# MARKED-UP CURRENT TECHNICAL SPECIFICATIONS

3) Timers to Start Dies a) Loss of Volt b) Low Voltag	el . age 1-Bus re 1-Bus	1/Bus 1/Bus	1/Bus VBus		16	
		(4) Timers to Shed Loa	ed VBus	1/Bus	1/Bus	$\sim$	16	
	DIA	BLO CANYON - UNITS 1 & 2		3/4 3-20		Unit 1 - Amendm Unit 2 - Amendm	ent 84) 12/ ent 89) 128

Attachment D PG&E Letter DCL-98-153

# MARKED-UP IMPROVED TECHNICAL SPECIFICATIONS

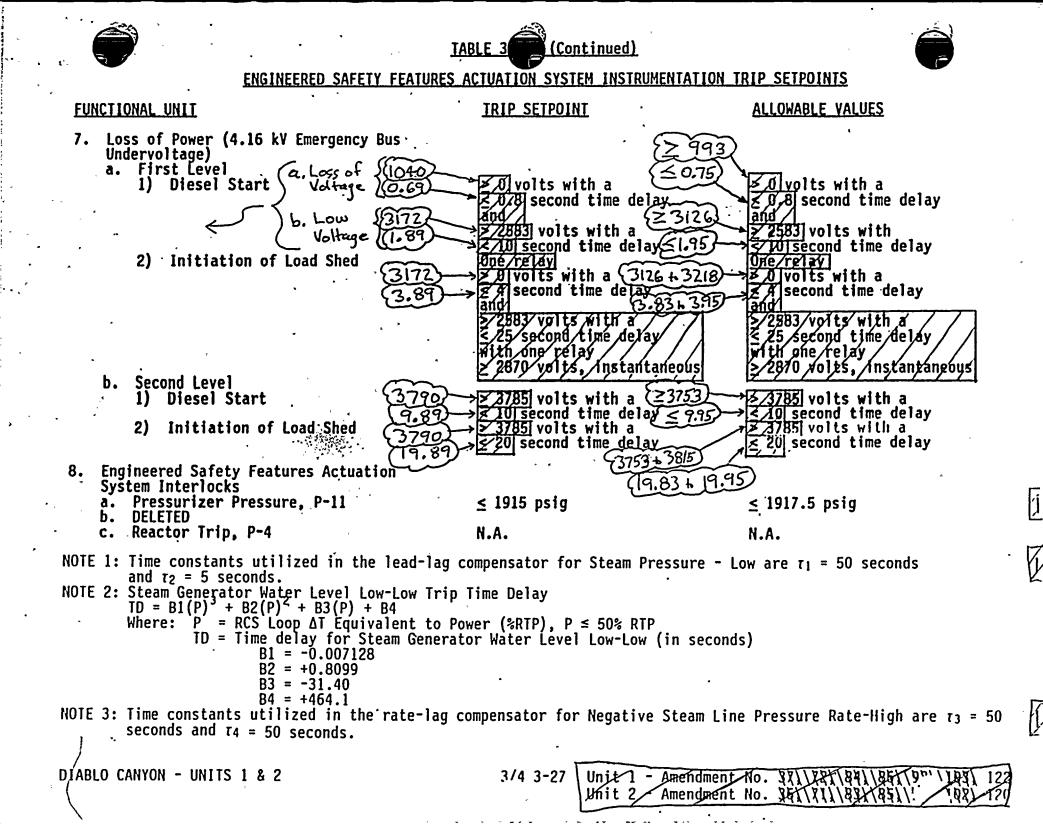
### Insert A

ACTION 36 - With the number of OPERABLE Channels less than the Total Number of Channels, declare the affected Emergency Diesel Generator(s) inoperable and comply with the ACTION statements of Specification 3.8.1.1; however, one channel may be bypassed for up to 2 hours for surveillance testing per Specification 4.3.2.1.
